REMARKS

In this Amendment, Applicant has cancelled Claims 1, 2, 5 – 7 and 20 without prejudice or disclaimer; and amended Claims 3, 4 and 8 – 19; and added new Claims 21 – 27. Claims 3, 4, 8 – 11, 17 and 18 have been amended to overcome the rejections and further specify the embodiments of the present invention. Claims 12 – 16 and 19 have been amended to proper dependent form. It is respectfully submitted that no new matter has been introduced by the amended and new claims. All claims are now present for examination and favorable reconsideration is respectfully requested in view of the preceding amendments and the following comments.

Fig. 1 (Prior Art)

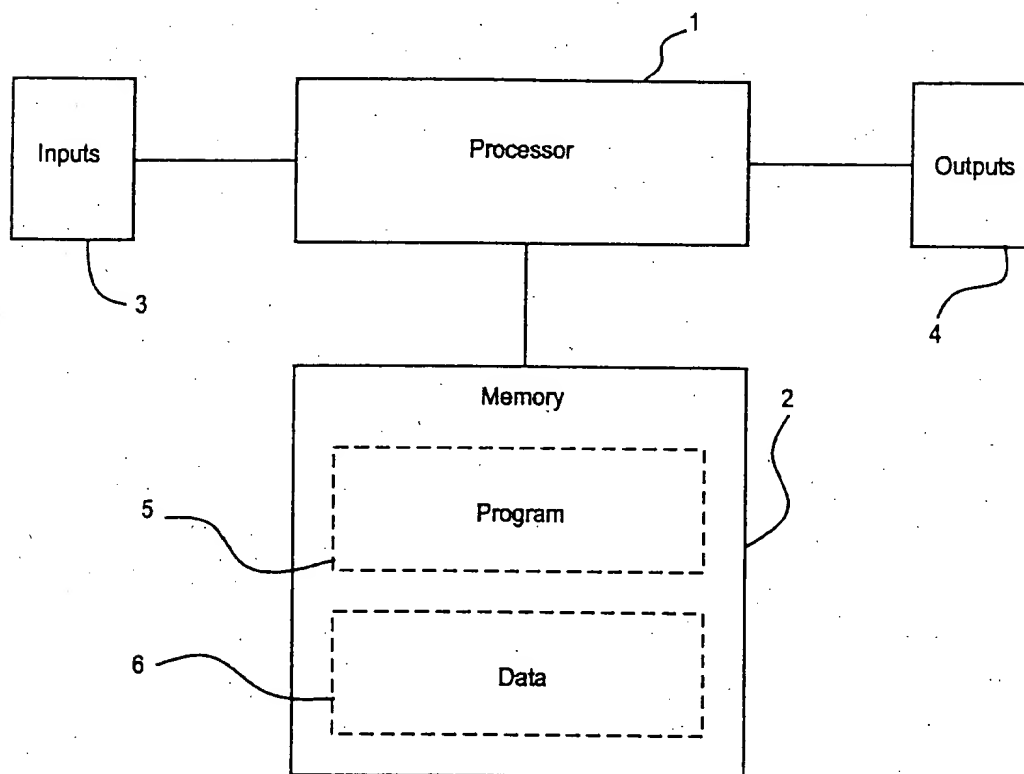
Figure 1 of the drawing has been objected as failing to identify as “Prior Art.”

The corrected drawing sheet has been provided. In the corrected Fig.1, legend of “Prior Art” has been added. Therefore, the objection to the drawing has been overcome and withdrawal of objection is respectfully requested.

The attached sheet of drawing includes changes to Fig.1. This sheet, which includes Fig. 1, replaces the original sheet including Fig. 1. In Fig. 1, legend of "Prior Art" has been added.
